W-6 UPPER SEGMENT: HWY 90 TO SW MILITARY DRIVE SEWER MAIN PROJECT

Solicitation Number: CO-00317

Job No.: 19-4519

ADDENDUM 1

DATE: FEBRUARY 2020	SAWS PROJECT NO. 19-4519	C72
DESIGN: KFA	KHA PROJECT NO. 068665052	
DRAWN: KFA		
CHECKED: KFA

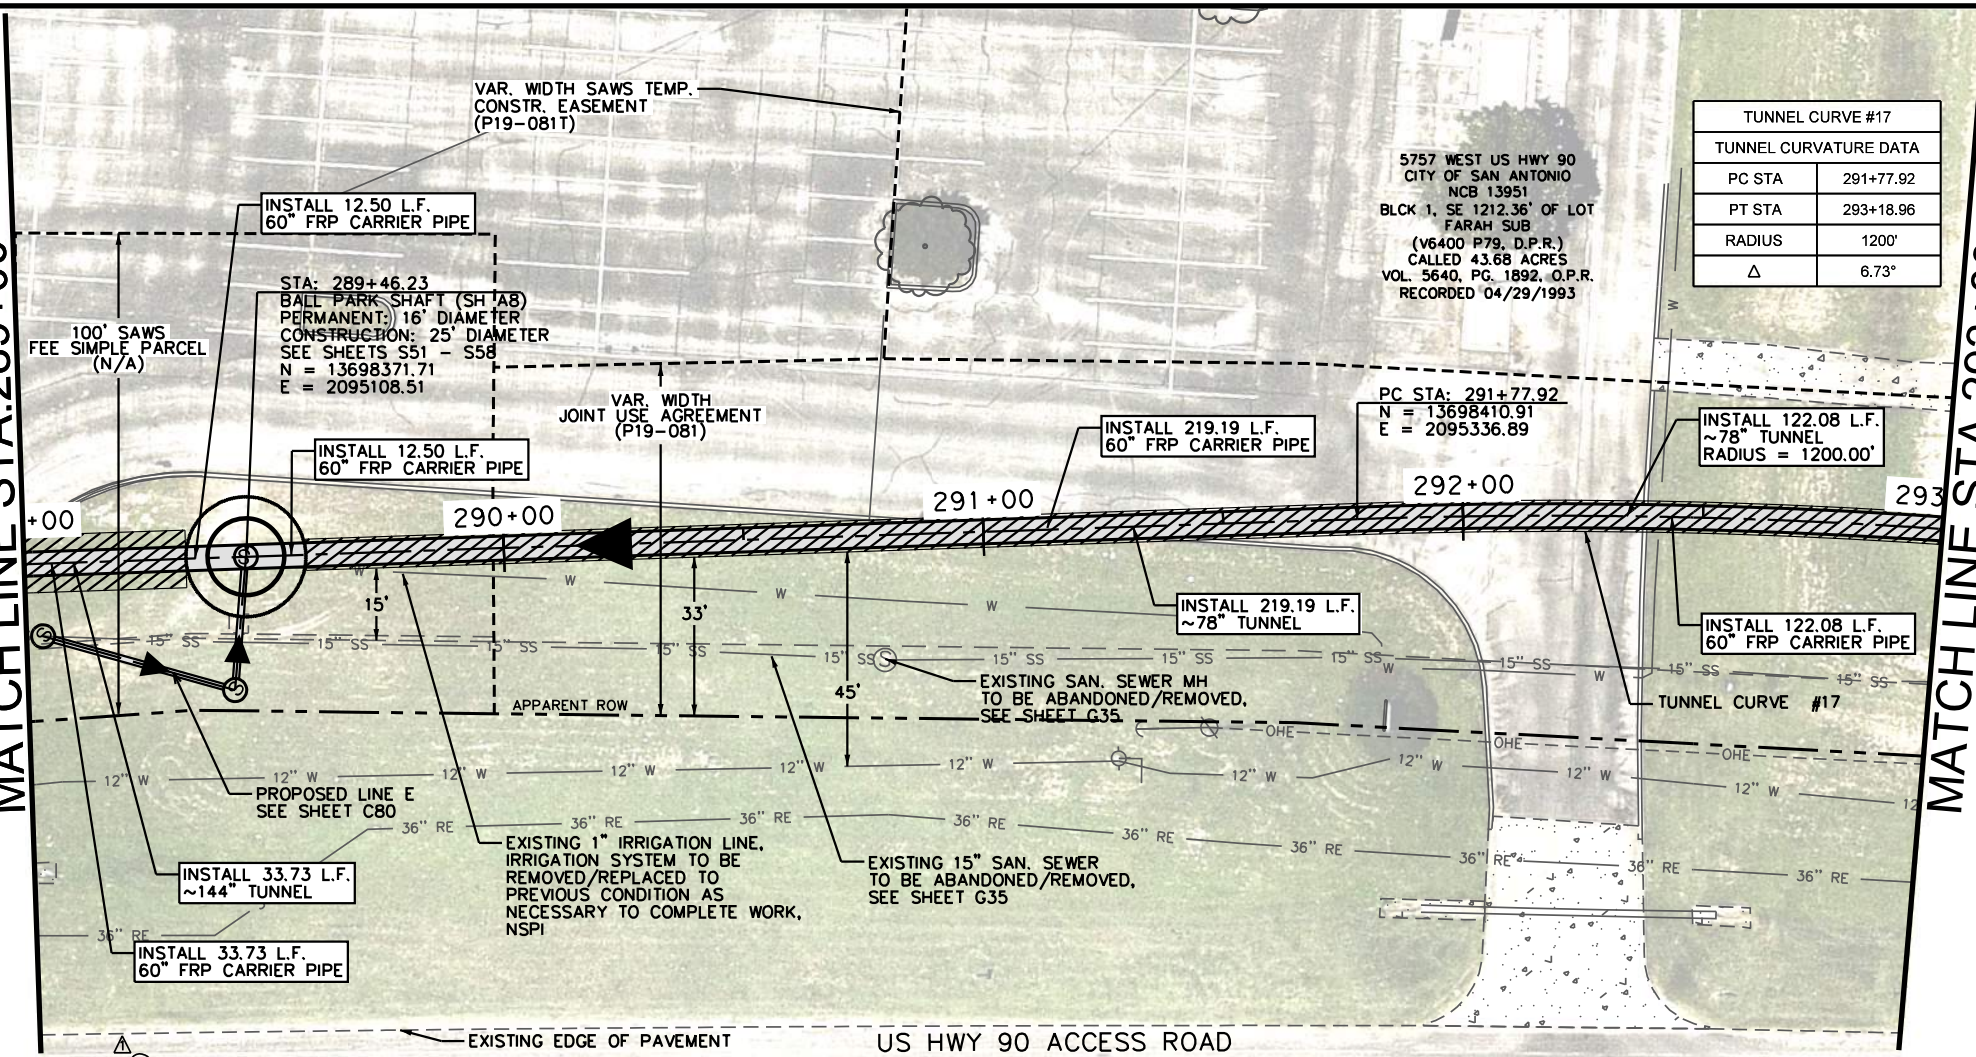
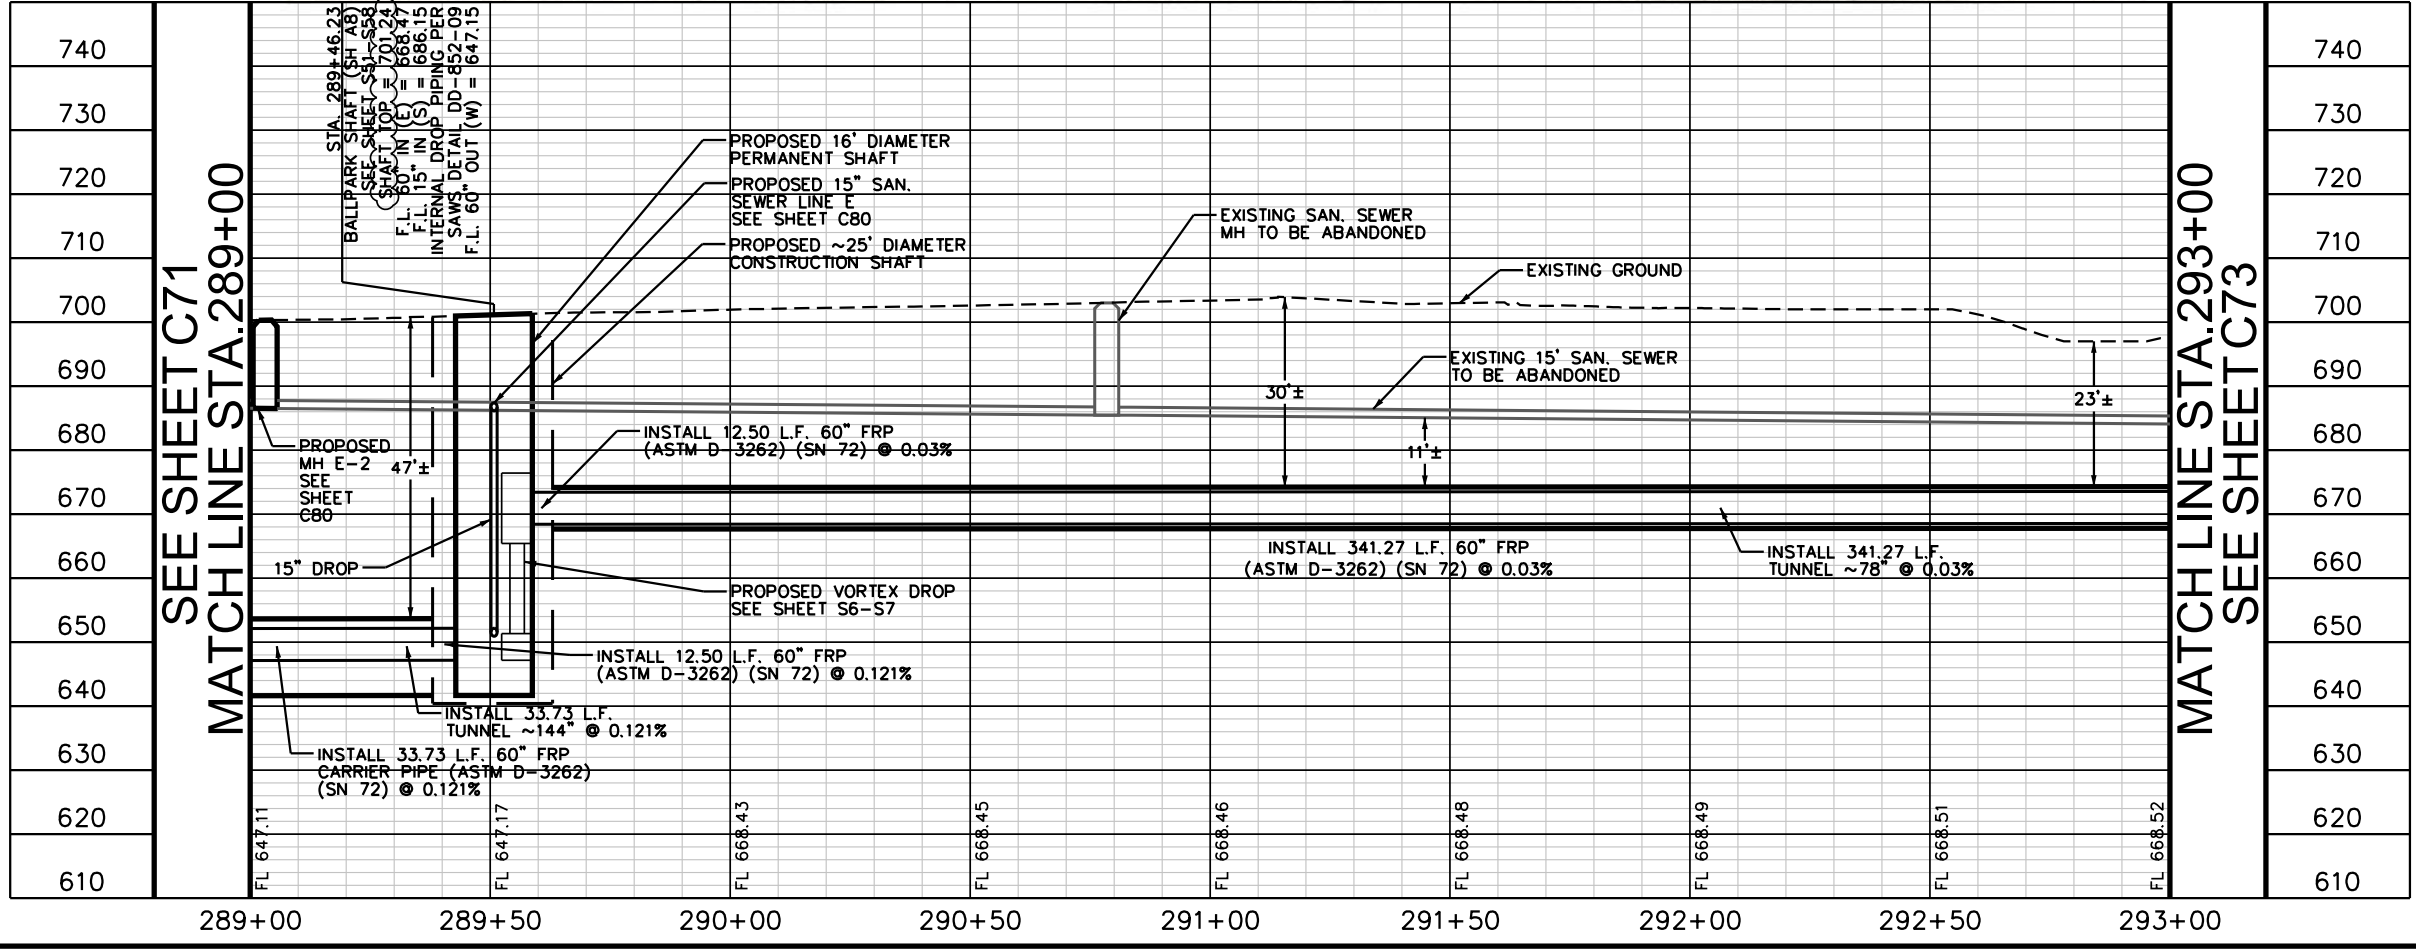
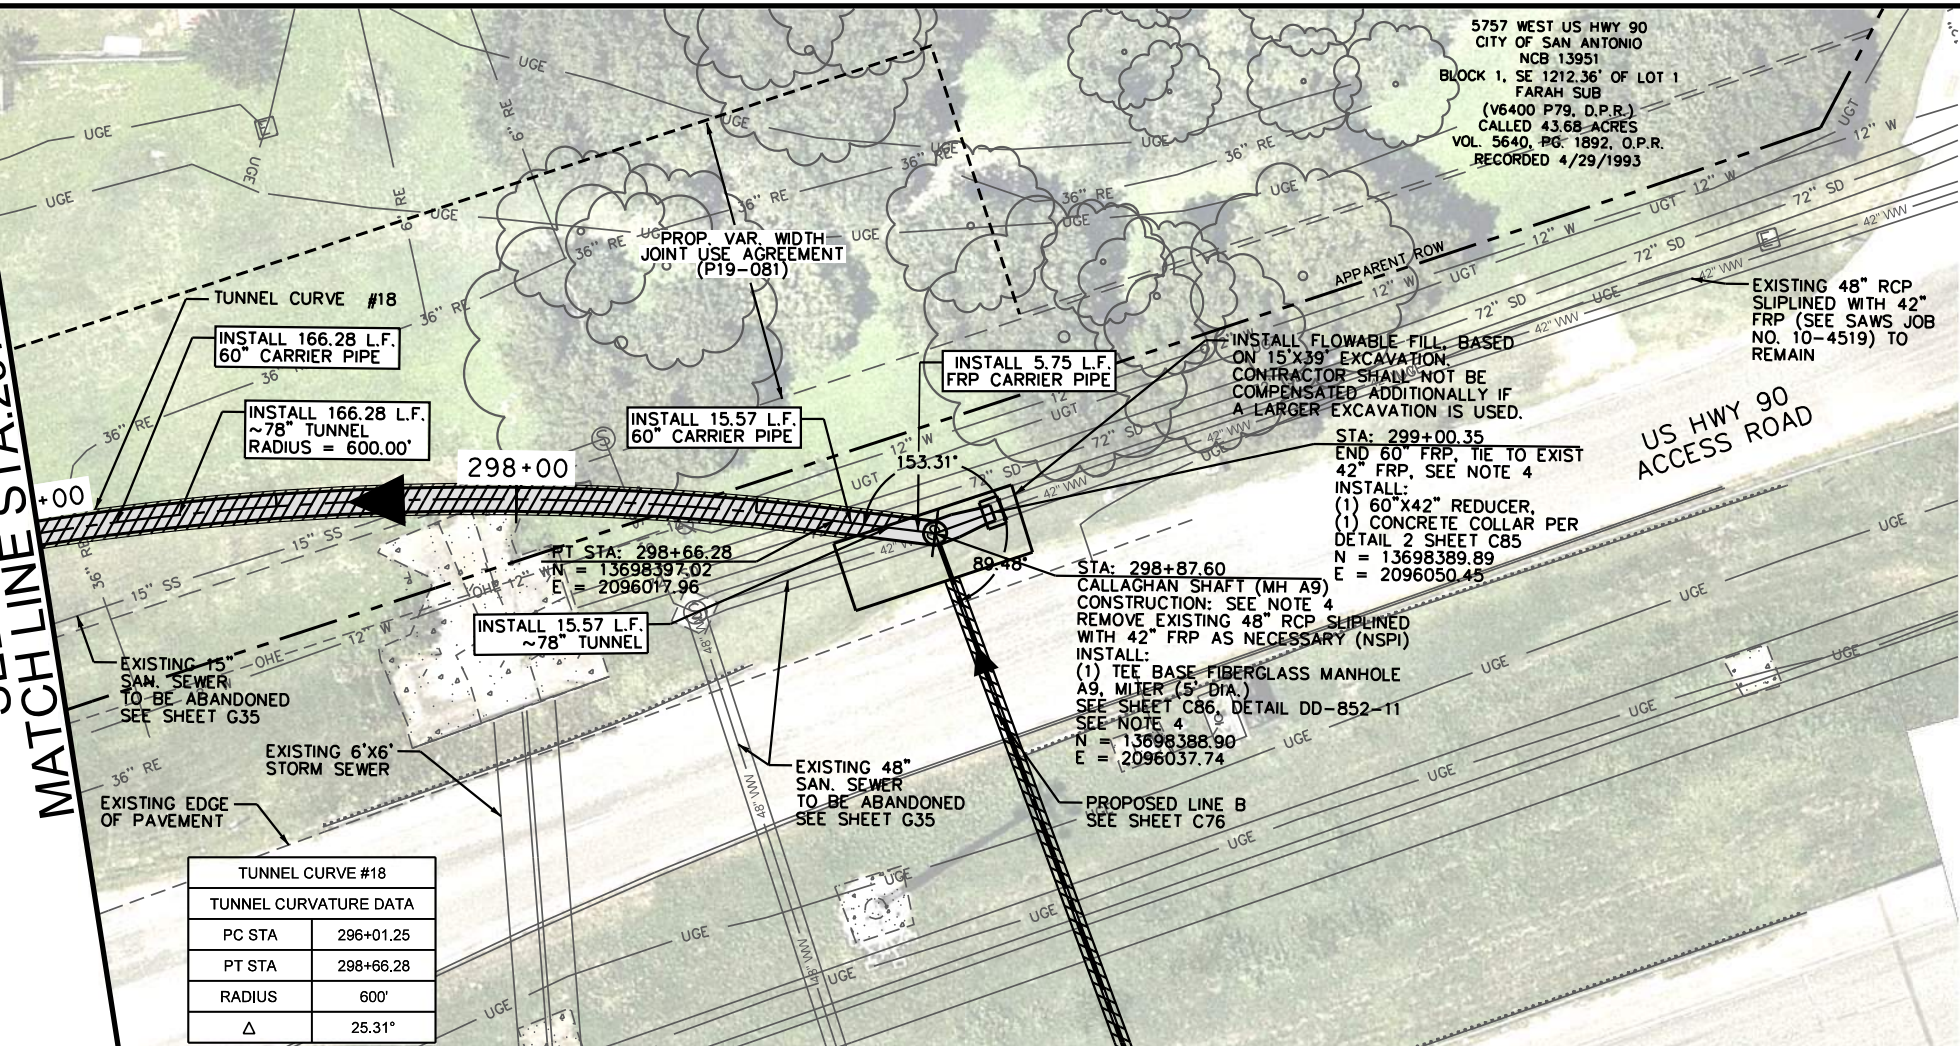
- Sheet C72- 60-INCH SANITARY SEWER PLAN & PROFILE - Revise and replace sheet in its entirety.
 - Label of shaft top rim elevation for Prop. Ballpark Shaft (SH A8)- “SHAFT TOP = 701.13” with the following: “SHAFT TOP = 701.24”.
